SUBJECT: ISSUANCE OF TECHNICAL SPECIFICATION AMENDMENTS FOR THE
SEQUOYAH NUCLEAR PLANT, UNITS 1 AND 2 (TAC NOS. MA2194 AND
MA2195)(TS 98-02)

Amendment No. 237
License No. DPR-77

Amendment No. 777
License No. DPR-79

SAFETY EVALUATION BY THE OFFICE OF NUCLEAR REACTOR REGULATION
RELATED TO AMENDMENT NO. 237 TO FACILITY OPERATING LICENSE NO. DPR-77
AND AMENDMENT NO. 227 TO FACILITY OPERATING LICENSE NO. DPR-79

FIGURE 3.4-1
DOSE EQUIVALENT I-131 Primary Coolant Specific Activity Limit Versus
Percent of RATED THERMAL POWER with the Primary Coolant Specific
Activity > 0.35 $\mu\text{Ci}/\text{gram}$ Dose Equivalent I-131

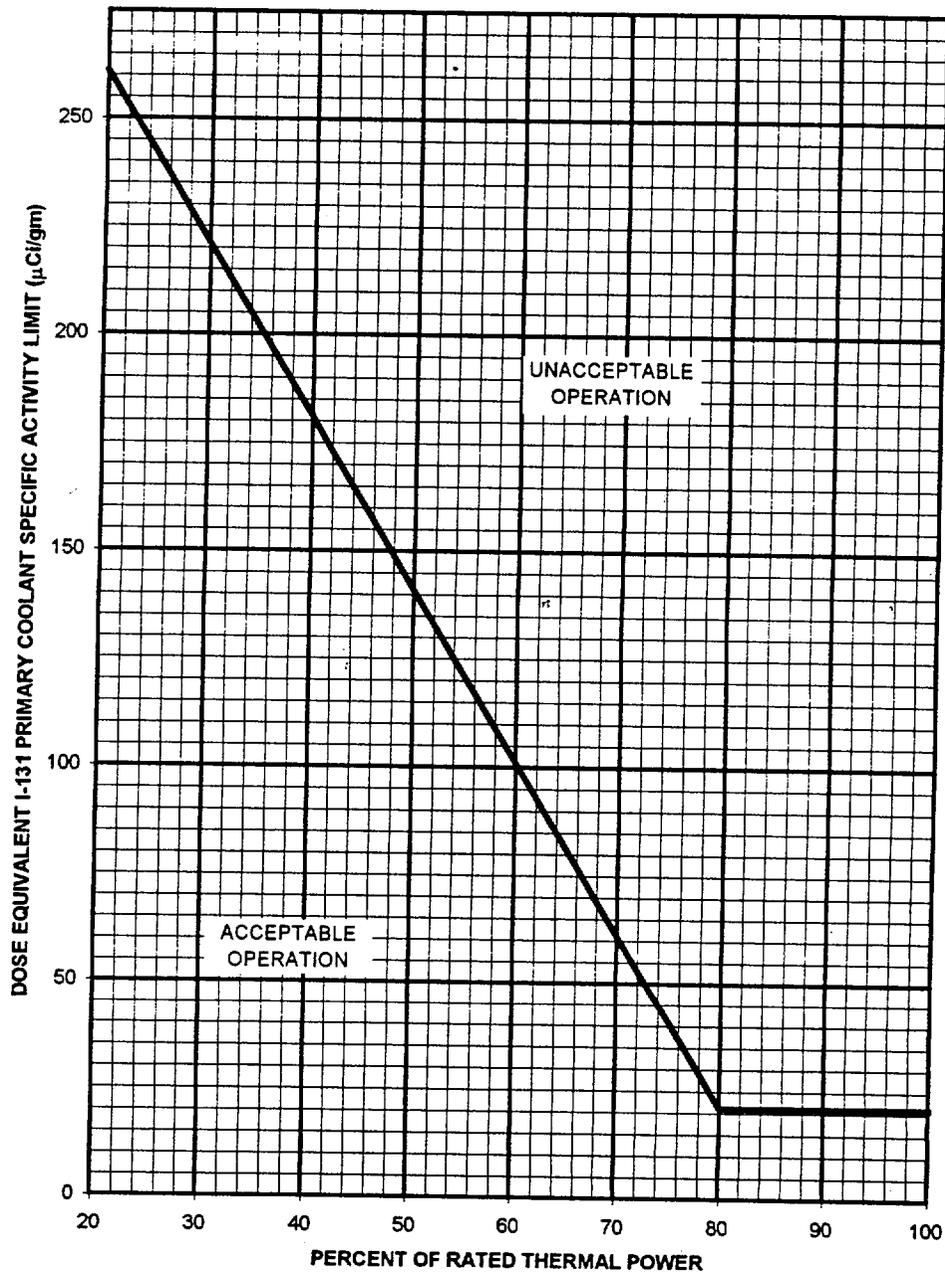
- a. With the specific activity of the primary coolant greater than 0.35 microcuries/gram DOSE EQUIVALENT I-131 for more than 48 hours during one continuous time interval or exceeding the limit line shown on Figure 3.4-1, be in at least HOT STANDBY with T_{avg} less than 500°F within 6 hours. | R121
- b. With the specific activity of the primary coolant greater than $100/\bar{E}$ microcuries/gram, be in at least HOT STANDBY with T_{avg} less than 500°F within 6 hours. | R121

The ACTION statement permitting POWER OPERATION to continue for limited time periods with the primary coolant's specific activity greater than or equal to 0.35 microcuries/gram DOSE EQUIVALENT I-131, but within the allowable limit shown on Figure 3.4-1, accommodates possible iodine spiking phenomenon which may occur following changes in THERMAL POWER. Operation with specific activity levels exceeding 0.35 microcuries/gram DOSE EQUIVALENT I-131 but within the limits shown on Figure 3.4-1 should be limited to no more than 800 hours per year since the activity levels allowed by Figure 3.4-1 increase the 2-hour thyroid dose at the site boundary by a factor of up to 20 following a postulated steam generator tube rupture.

With the proposed change to TS Figure 3.4-1, the unacceptable range of operation, the maximum allowable specific activity level at which the plant would be required to initiate shutdown actions at rated thermal power levels of 80% or above, would now be at primary coolant activity levels greater than 20 microcuries per gram ($\mu\text{Ci/g}$) of dose equivalent ^{131}I . Previously, this value had been 60 $\mu\text{Ci/g}$. A similar reduction in primary coolant activity levels of dose equivalent ^{131}I in the power range 20-80% was incorporated into the figure.

FIGURE 3.4-1
DOSE EQUIVALENT I-131 Primary Coolant Specific Activity Limit Versus
Percent of RATED THERMAL POWER with the Primary Coolant Specific
Activity > 0.35 $\mu\text{Ci}/\text{gram}$ Dose Equivalent I-131

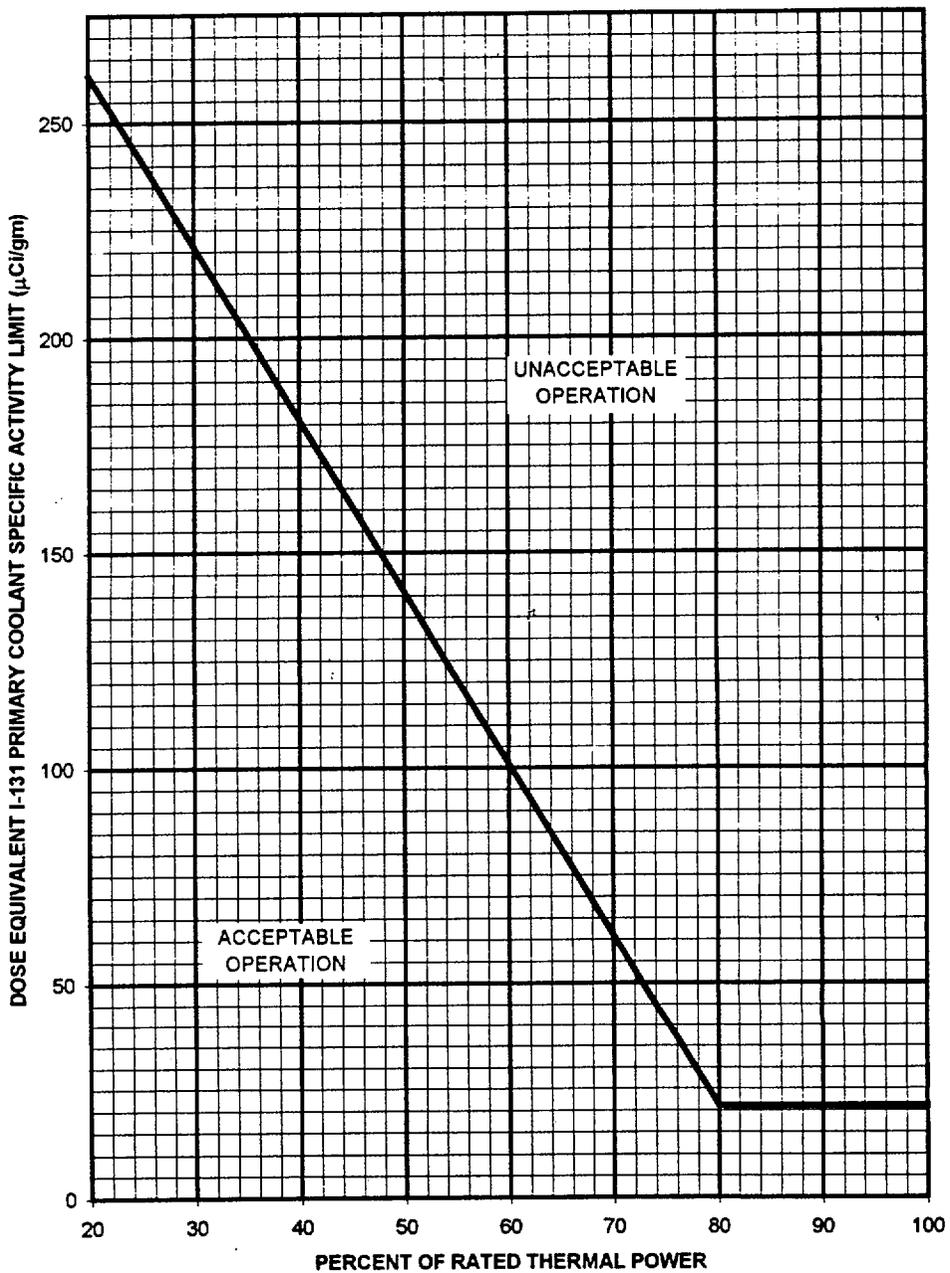
- a. With the specific activity of the primary coolant greater than 0.35 microcurie per gram DOSE EQUIVALENT I-131 for more than 48 hours during one continuous time interval or exceeding the limit line shown on Figure 3.4-1, be in at least HOT STANDBY with T_{avg} less than 500°F within 6 hours. | R107
- b. With the specific activity of the primary coolant greater than $100/\bar{E}$ microcurie per gram, be in at least HOT STANDBY with T_{avg} less than , 500°F within 6 hours. | R107

The ACTION statement permitting POWER OPERATION to continue for limited time periods with the primary coolant's specific activity greater than 0.35 microcuries/gram DOSE EQUIVALENT I-131, but within the allowable limit shown on Figure 3.4-1, accommodates possible iodine spiking phenomenon which may occur following changes in THERMAL POWER. Operation with specific activity levels exceeding 0.35 microcuries/gram DOSE EQUIVALENT I-131 but within the limits shown on Figure 3.4-1 should be limited to no more than 800 hours per year since the activity levels allowed by Figure 3.4-1 increase the 2-hour thyroid dose at the site boundary by a factor of up to 20 following a postulated steam generator tube rupture.
